GEOCRES No. SOM 12-87DIST. 6 REGION W.P. No. 127-66-12CONT. No. 79-77W. O. No. STR. SITE No. 24-319HWY. No. 410/403LOCATION Prop Str. #37 at Crossing  
of Eglinham AveNo of PAGES - =====OVERSIZE DRAWINGS TO BE INCLUDED WITH THIS REPORT. REMARKS:

EGLINTON AVE. UNDERPASS  
BRIDGE 37

*CONT 79-77*  
FOUNDATION INVESTIGATION REPORT

For  
The Proposed Structure No. 37  
At the Crossing of  
Eglinton Avenue (Base Line Road) and  
Hwy. #410 & Hwy. #403, Site #24-319  
Town of Mississauga, County of Peel  
District #6 (Toronto)  
W.O. 73-11032 -- W.P. 127-66-12

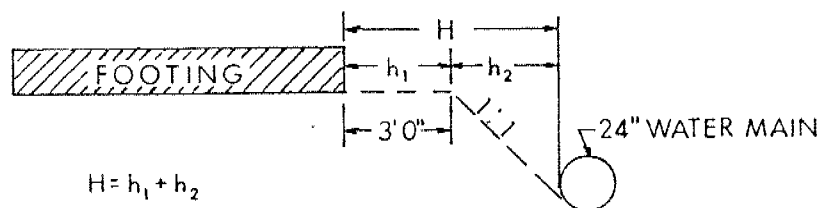
In response to your two memoranda with regard to the above mentioned project, we have reviewed the pertinent subsurface data and submit the following comments:

1. The revised footing locations necessitated by the redesign due to median width and reduction in the lane requirements were carefully reviewed. We conclude that our recommendations and subsurface data contained in the foundation report (W.O. 73-11032 dated August 2, 1973), are still applicable.
2. With regard to the treatment of the existing 24"  $\phi$  watermain on the north side of the Eglinton Avenue which will be left in place, we suggest the following measures to be adopted during the time of design and construction.

- a) If the sewer is at the same base elevation of the footing then  $h_2 = 0$  and  $H = 3$  feet.
- b) If the sewer is lower than the base elevation of the footing then  $H = h_1 + h_2$   
 $= 3 \text{ ft.} + h_2$  (minimum 1:1 slope as shown on the figure)
